SUBJECT: DRAFT 1 OF PROPOSED REVISION 1 TO REGULATORY GUIDE
1.131, "QUALIFICATION TESTS OF ELECTRIC CABLES AND
FIELD SPLICES FOR LIGHT-WATER-COOLED NUCLEAR POWER
PLANTS"

Draft 1
March 5, 1979

REGULATORY GUIDE 1.131

QUALIFICATION TESTS OF ELECTRIC CABLES, FIELD SPLICES, ~~AND CONNECTIONS~~ FOR LIGHT-WATER-COOLED NUCLEAR POWER PLANTS

Figure 1 - Enclosure

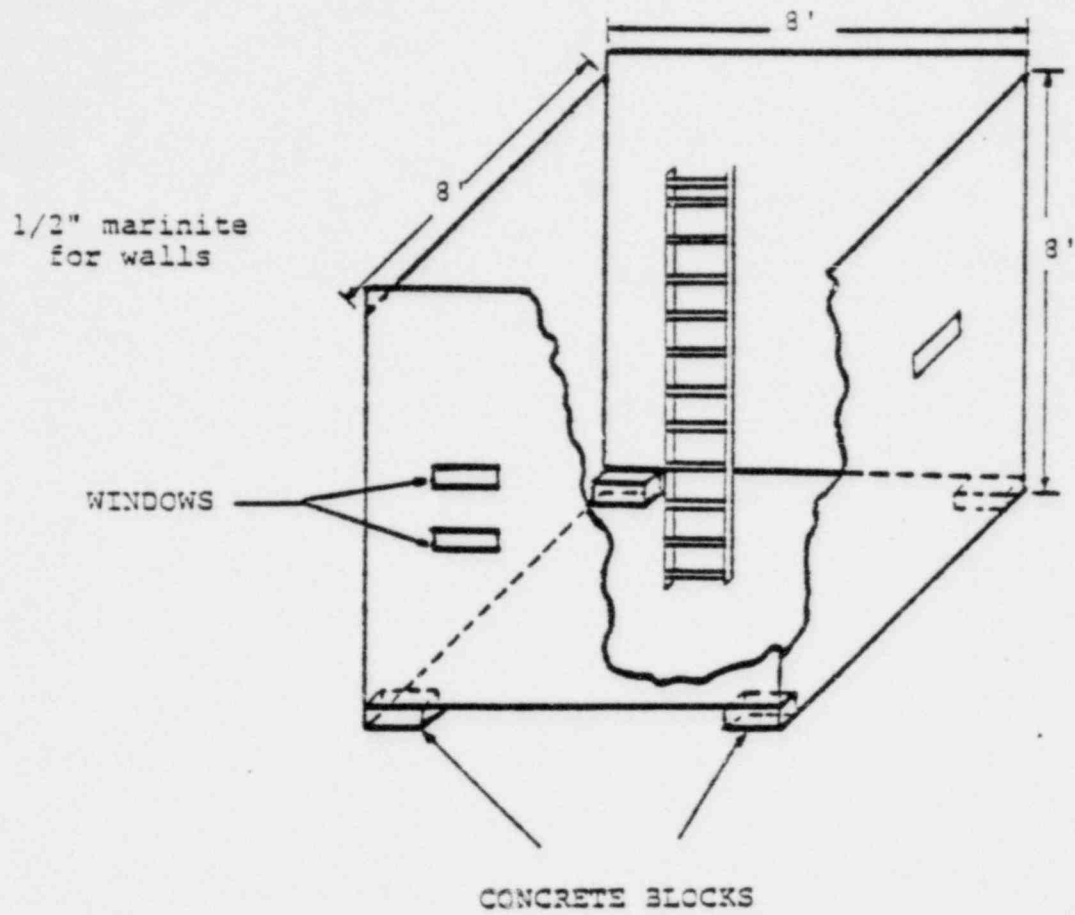
9. In lieu of Section 2.5.4.1, the following should be used: "Tests shall be conducted within a test enclosure. The test enclosure shall be a nominal 8 ft x 8 ft x 8 ft compartment as shown in Figure 1. The interior surfaces of the enclosure shall be mineral material such as Marinite board, or similar inorganic material. Several observation windows and an access door shall be provided. The interior surface shall be painted flat black. A nominal 12 inch high opening shall be provided at floor level across the entire front and rear walls. The top of the enclosure shall be completely open. Ventilation of the building or room in which the test is conducted shall be sufficient to prevent oxygen depletion by recirculation of combustion products. Ambient air and cable tray temperature shall be $78^{\circ} \pm 5^{\circ}F$ prior to each test.

Figure 2 - Test Setup

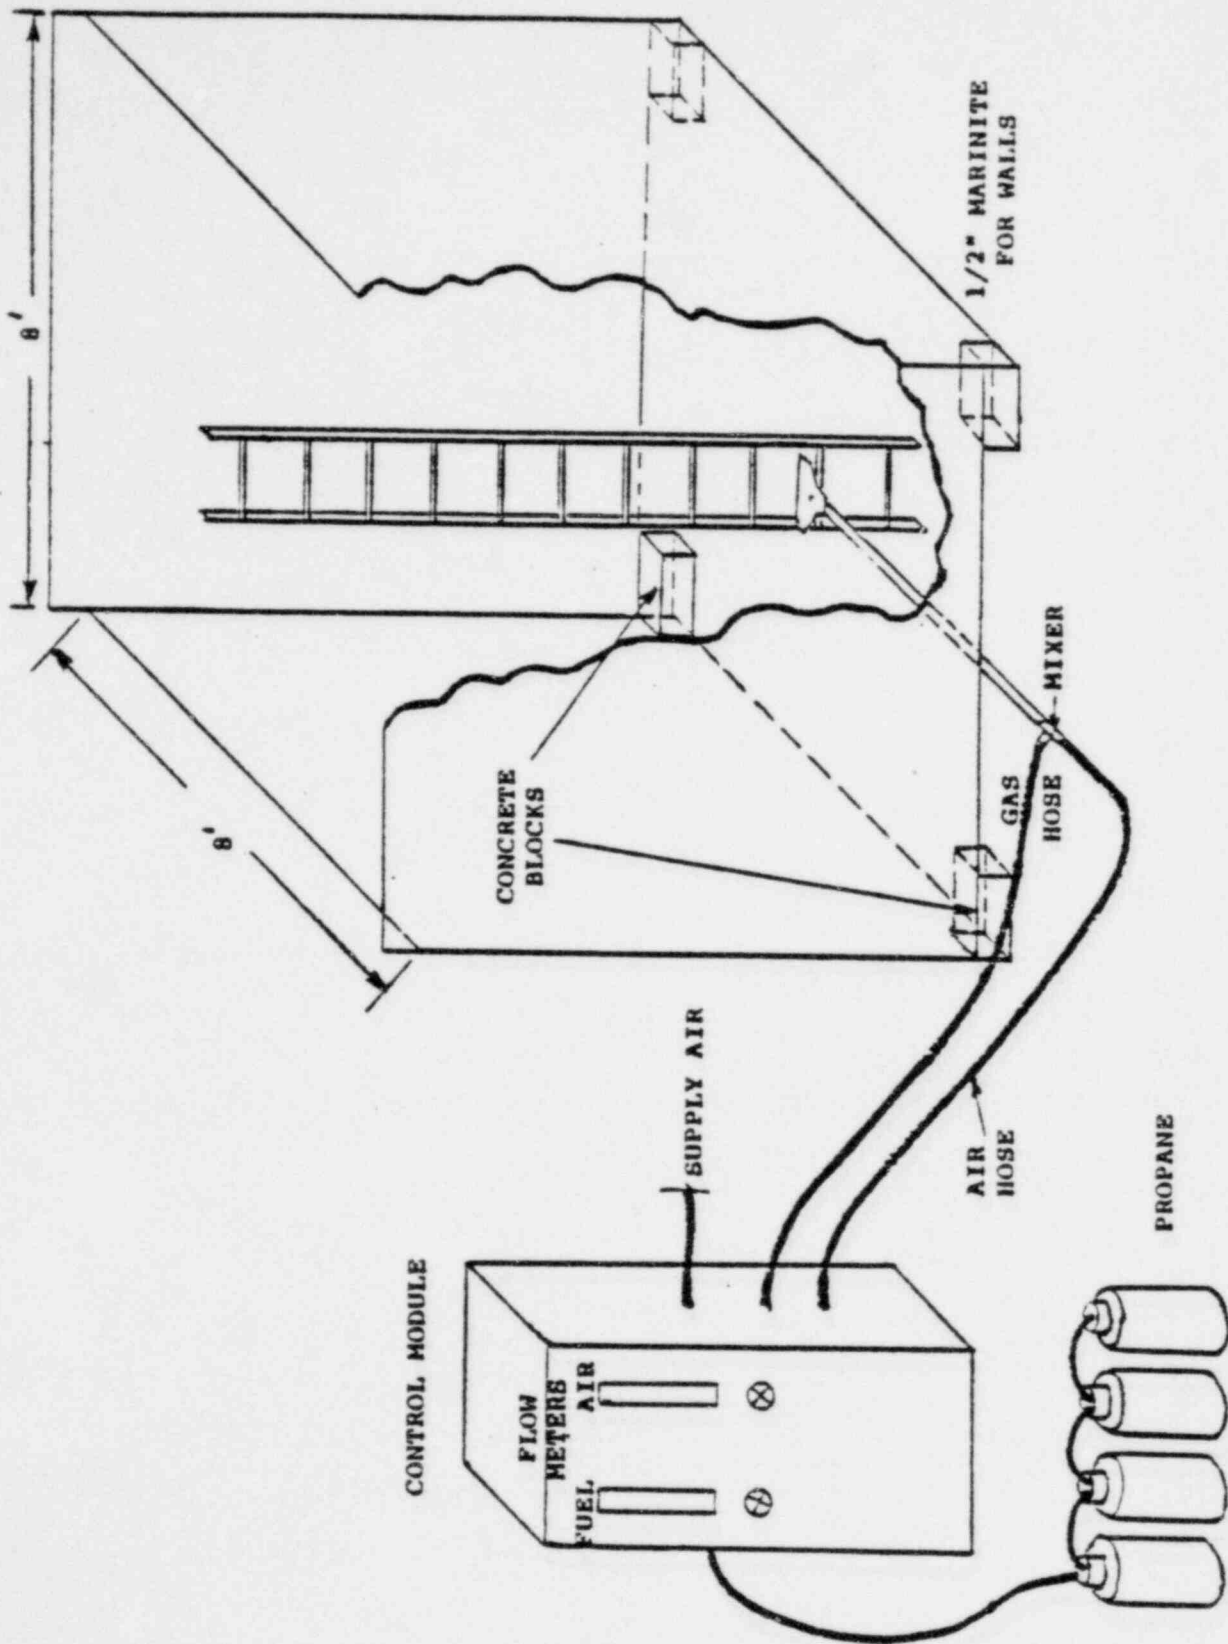
~~The proper flame source shall be achieved when the fuel input rate is 70,000 ± 1,600 BTU per hour and the supply air flow is 163 ± 10 standard cubic feet per hour. Flow rates are to be monitored by rotameters as shown in Figure 2.~~

"The proper flame source shall be achieved when the fuel input rate is 70,000 ± 1,600 BTU per hour and the supply air flow is 163 ± 10 standard cubic feet per hour. Flow rates are to be monitored by rotameters as shown in Figure 2.
